7060000 RAISED PAVEMENT MARKERS AND BITUMINOUS ADHESIVE
COMMENTS FROM INTERNAL/INDUSTRY REVIEW

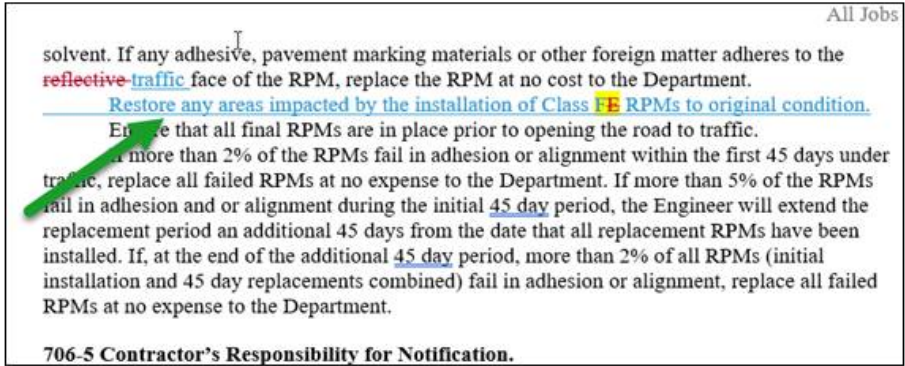
Could we update the spec as follows (or something similar), to cover projects without Final Surface markings? We still have enough push button and non-resurfacing projects using the pay item. Proposed changes in blue highlight
 No need to specify class in pay item description; one pay item “group” will cover both types.

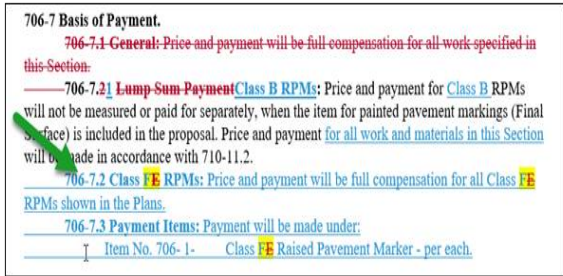
First question concerns the sentence indicated by the green arrow in the first screen shot below. The language seems rather vague and therefore highly questionable regarding its enforceability. No reply required, but I just wanted to ask the question. If Specs Office feels it is enforceable, then I have no further comments.

Should the Class B RPM's have some language regarding "all work and materials"? (See green arrow in screenshot below.) It would appear the Class F language could be misconstrued to mean only the material cost is covered by a 706 pay item. Maybe full compensation covers it, but I just wanted to check that the different language used in each is due to paying for each differently. It very well may be the case, but I just wanted to ask the question regarding the different language. If both, Class B and Class F payment includes all work and materials, then I'd suggest it be stated for both.
